CITY OF BURLINGTON, VERMONT
CITY COUNCIL TRANSPORTATION, ENERGY & UTILITIES COMMITTEE

DRAFT Meeting Minutes for the Transportation, Energy, and Utilities Committee

4. Saint Paul Street Great Streets Project Update

Fig. 6 Pre Construction Condition Single Unit Truck SU-30 Turning

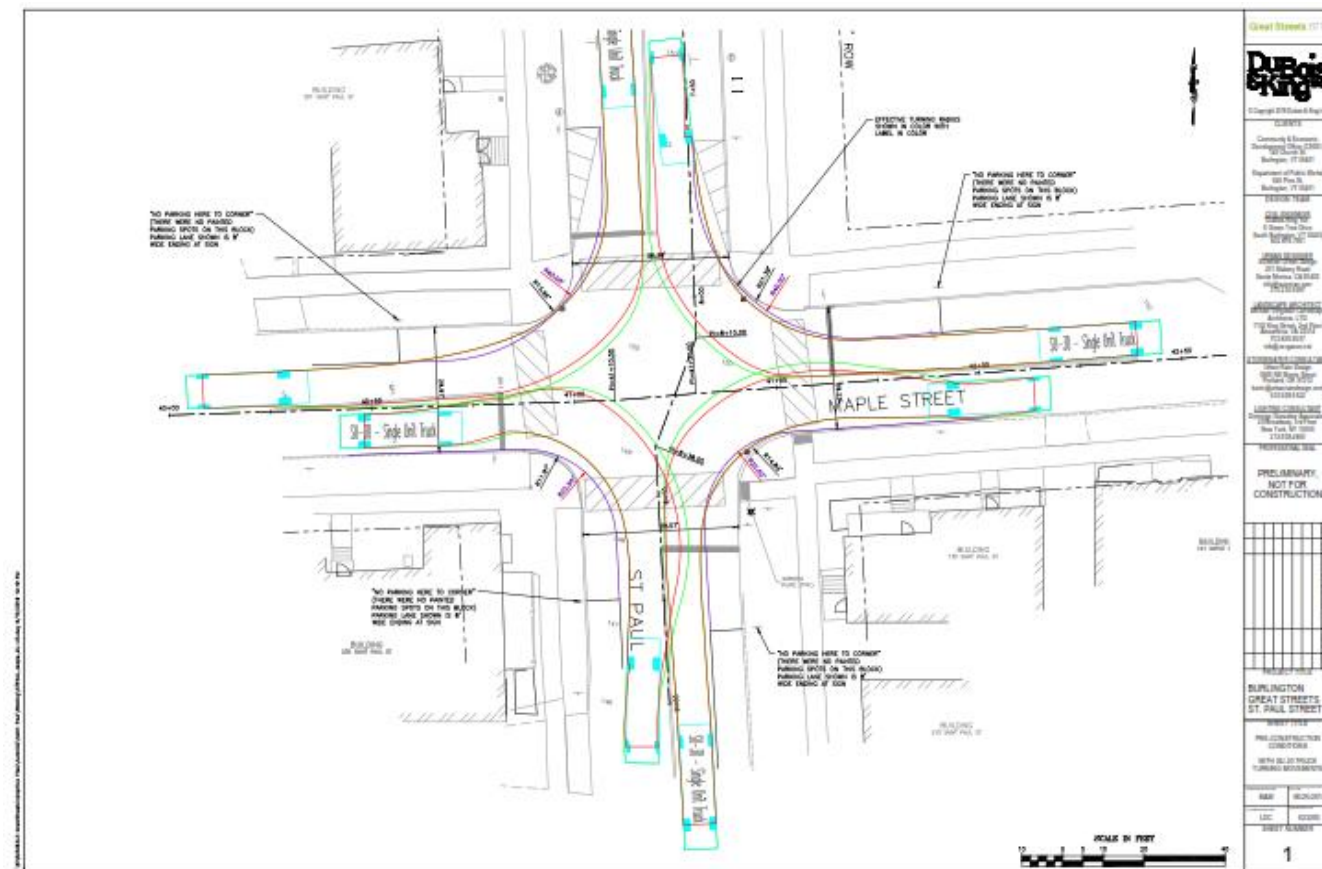
The intersection of Maple and St.Paul Street prior to construction had corner radius and effective radius of:

- └ Curb Radius 11.97', Effective Radius S.B. Right Turn 22.5'-Southwest Corner
- └ Curb Radius 14.83', Effective Radius E.B. Right Turn 22.5'-Southeast Corner
- └ Curb Radius 13.95', Effective Radius S.B. Right Turn 40.0'-Northwest Corner
- └ Curb Radius 21.39', Effective Radius W.B. Right Turn 40.0'-Northeast Corner

See Fig. 6 Below, please note Eastbound Right Turn and Northbound Right Turns overlap and the Single Unit Truck SU-30 cannot make the same movement at the same time under pre construction condition.

Fig.10-Maple & St.Paul 20' Curb Radius

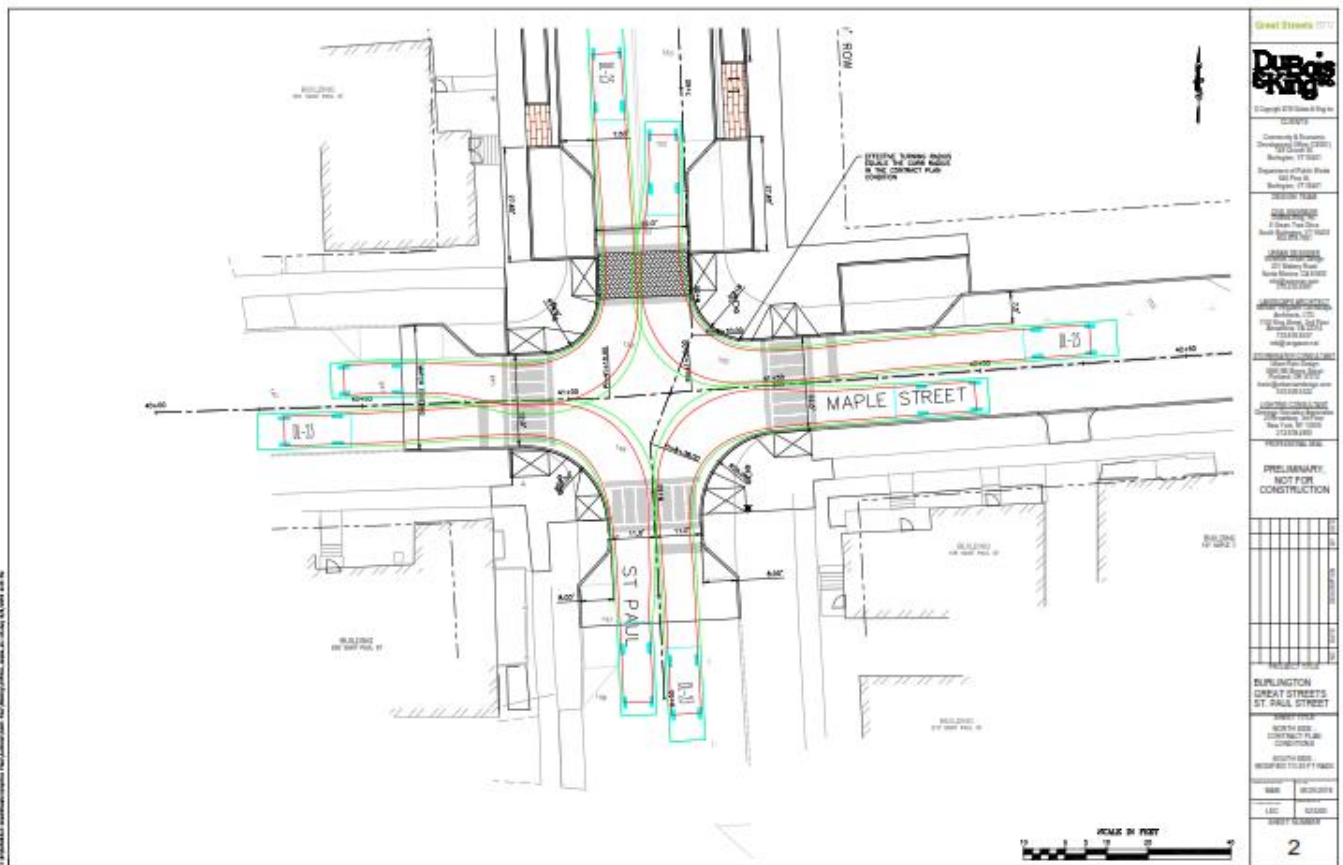
- In our analysis we did three iterations. One was a 20' radius, no curb return with no reduction in the bumpouts, and 20' radius with a 2' reduction in the bumpout, and 20' radius with a 4' reduction in the bumpout. From those iterations and applying the turning movements, specifically for the DL23, we believe these turning movements can occur concurrently without having the problems and challenges we have been having. Single unit trucks can also make that movement but with some overlap into the other lane.

Fig.12-Maple Street and St.Paul Street-20' Curb Radius, 8' widening of northbound approach

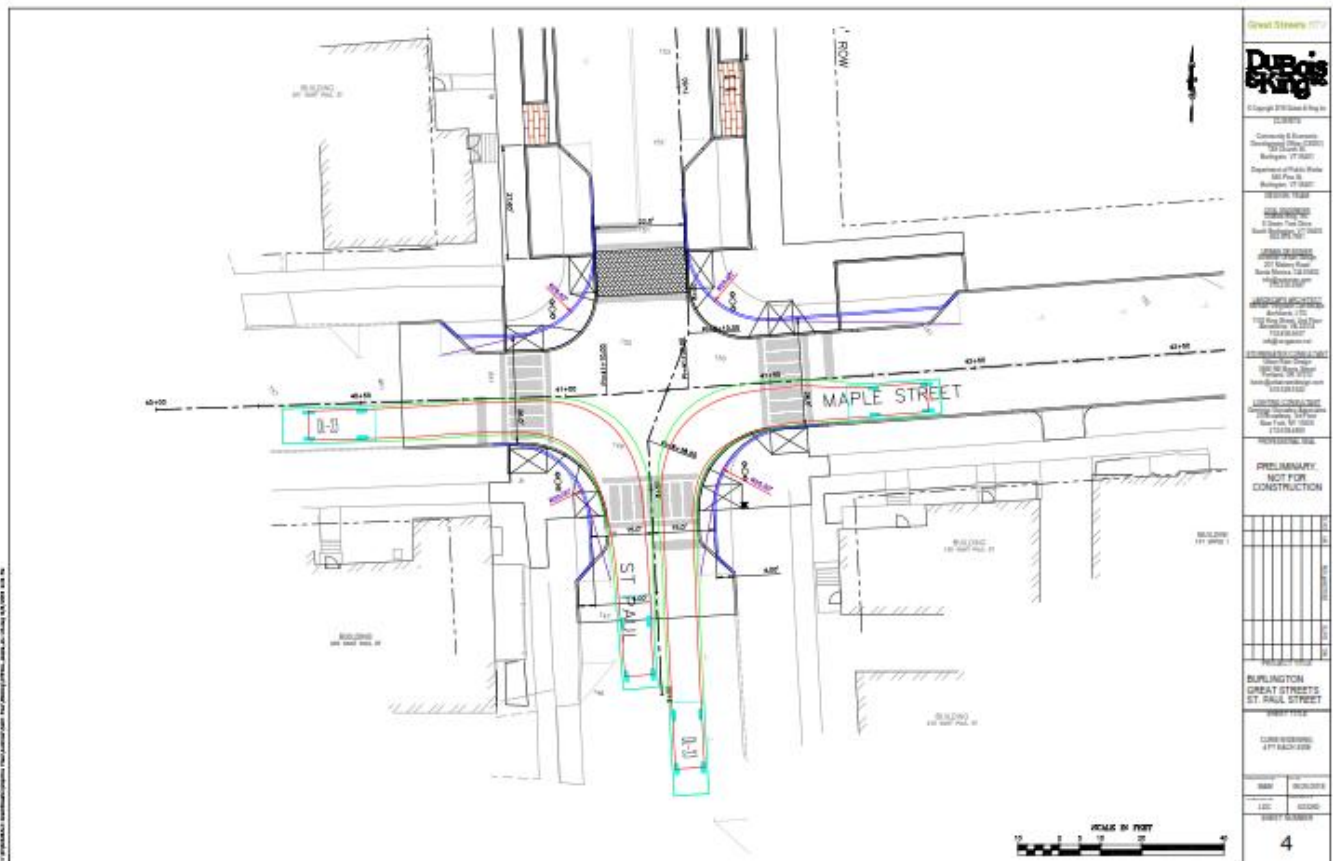
DPW has concluded that the intersection of Maple and St.Paul Street as built, requires modifications. In attempting to create the a new balance in how the public will make use of the right of way, we recognize our first attempt at finding the right balance of accommodating pedestrians and vehicular movement did not arrive at a favorable result for the public.

Therefore the design modifications identified in Fig. 12, calling for a 20' radius for the two southern most corners and an 8' widening of the northbound approach at Maple and St.Paul is the design modifications DPW would recommend in this case.
